UNITED STATES PATENT AND TRADEMARK OFFICE

APPLICATION NO.	FILING DATE	FIRST NAMED INVENTOR	ATTORNEY DOCKET NO.	CONFIRMATION NO.
10/681,983	10/09/2003	Chun Ho Fan	618902001410	8846
25227 7590 01/28/2008 MORRISON & FOERSTER LLP 1650 TYSONS BOULEVARD SUITE 400 MCLEAN, VA 22102			EXAMINER ANDUJAR, LEONARDO	
			ART UNIT 2826	PAPER NUMBER
			MAIL DATE 01/28/2008	DELIVERY MODE PAPER

Office Action Summary	Application No.		Applicant(s)	
	10/681,983		FAN ET AL.	
	Examiner		Art Unit	
	Leonardo Andújar		2826

DETAILED ACTION

FIG. 7

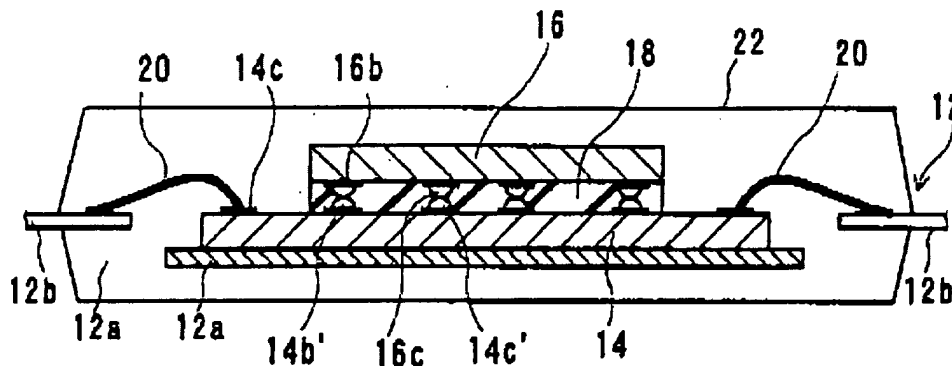
4. Regarding claim 11, Tesjui (e.g. fig. 11b) shows a integrated circuit package comprising: a first lead frame 133 having a first side and a second side, opposite the first side; a second lead frame 139 laminated to the first side of the first lead frame (e.g. top side) in order to create a multi layer lead frame; and a semiconductor die 134 mounted to another portion of the first side of the first leadframe

It would have been obvious to one of ordinary skill in the art at the time the invention was made to include contact balls on the semiconductor die disclosed by Tsuji

in accordance with Morifuji's invention to increase the integration density while preventing the semiconductor chip from warping and from being damaged.
